Re: **Request for Additional Information**  
Thompson S. Baker Cement Plant – Kiln 2 System  
Project No. 0010087-031-AC (PSD-FL-350A)  
Revision of Permit No. PSD-FL-350 (Project No. 0010087-013-AC)

RE: RAI dated February 7, 2008, for Project No. 0010087-031-AC (PSD-FL-350A)  
Facility ID 0010087

RE: Correction to Draft Permit No. 0010087-031-AC (PSD-FL-350A)  
Florida Rock Industries, Inc.—Thompson S. Baker Cement Plant  
Facility ID 0010087

**MECHANICAL PROCESS FLOW SHEET  
HOMOGENIZING SILO AND KILN FEED  
2300 STPD CLUNKER**

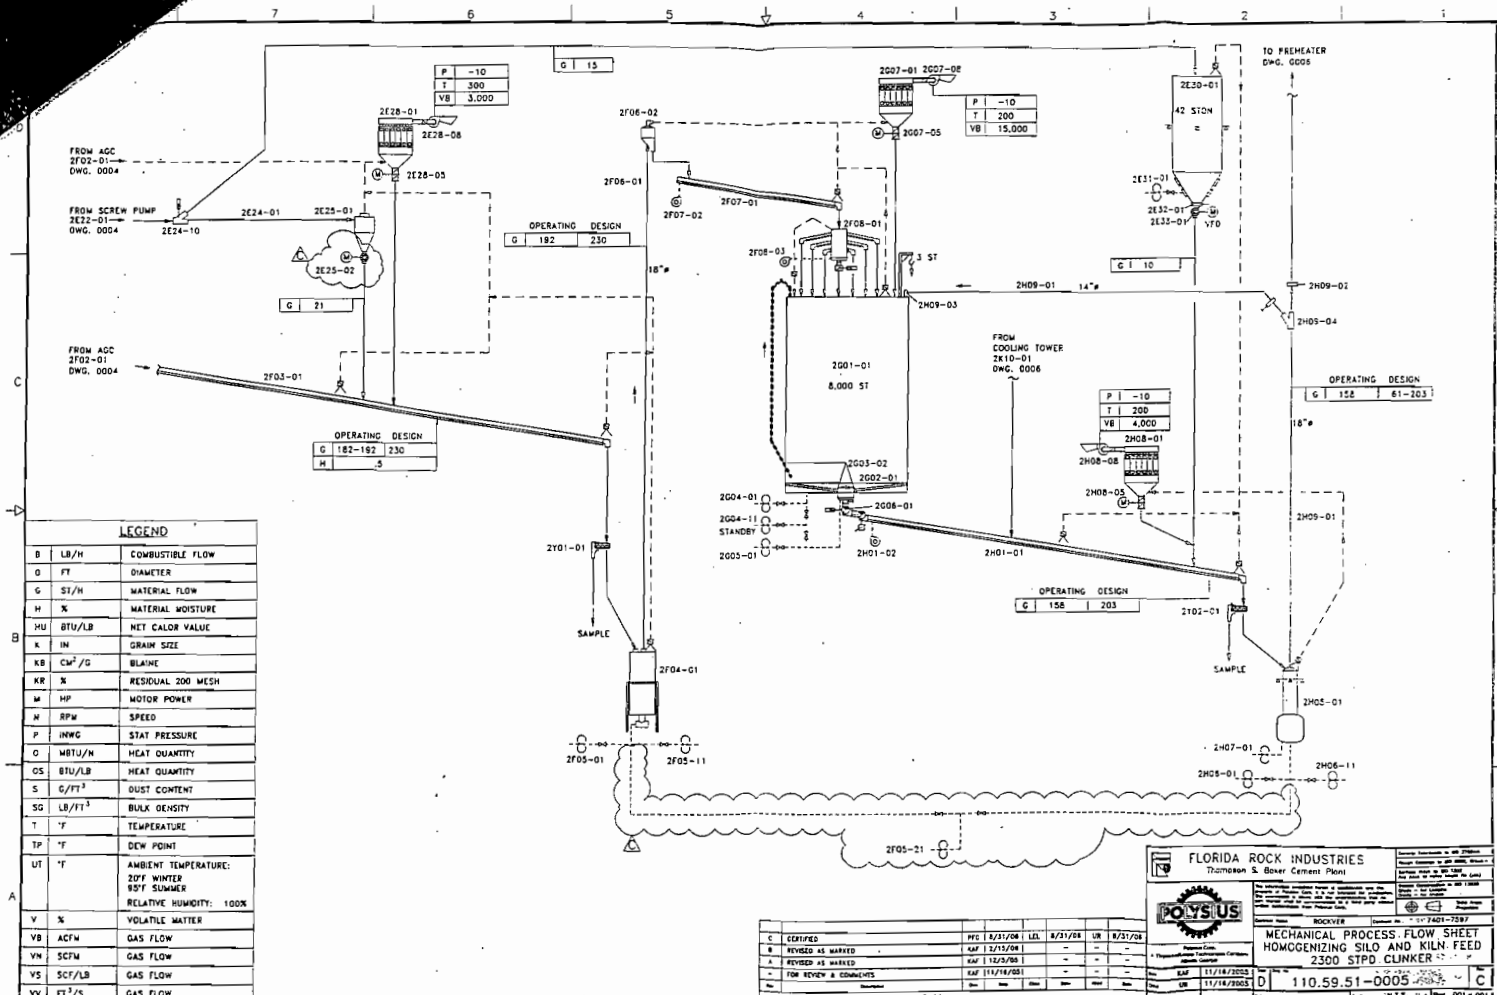
The first correction is to the description of baghouse 2H08 at the bottom of the table under condition 13. Specifically, we request that the description be made to read "Homogenizing silo to the preheater feed *and bin 2E30*". Drawing no. 110.59.51-0005, which you have on file as part of our earlier applications, is highlighted to show this relationship.

**MECHANICAL PROCESS FLOW SHEET  
CLINKER SILOS AND ADDITIVES; LINE 1  
2300 STPD CLINKER**

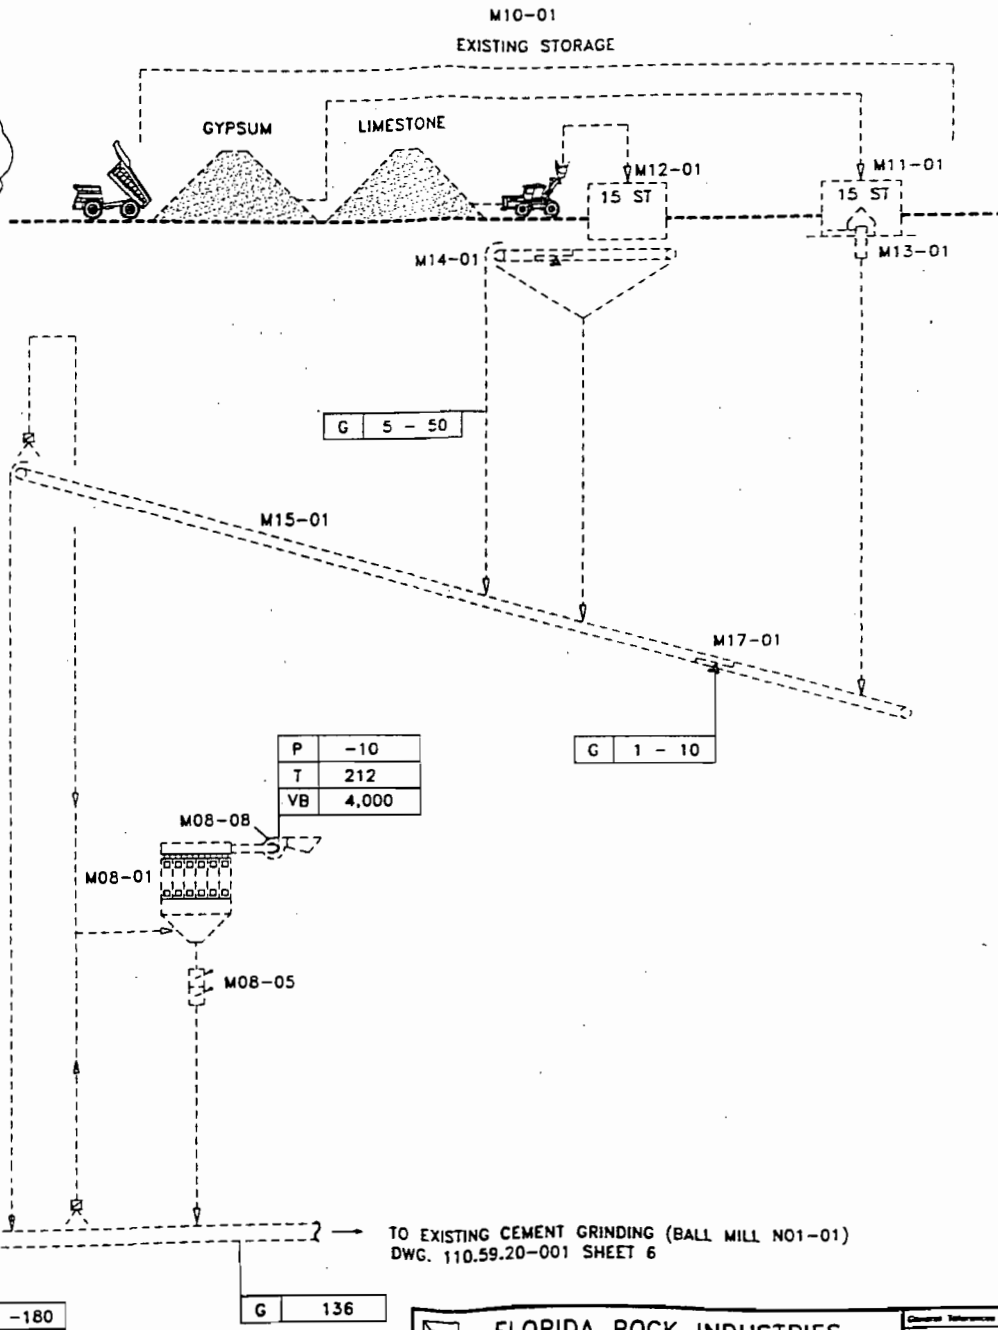
The second correction is to the description of emission point 2L15 under condition 16. Specifically, we request that the description be made to read "Clinker Transport (2L20, *silo L07-02*, and 2L09)". Drawing no. 110.59.51-0007, which you have on file as part of our earlier applications, is highlighted to show this relationship.
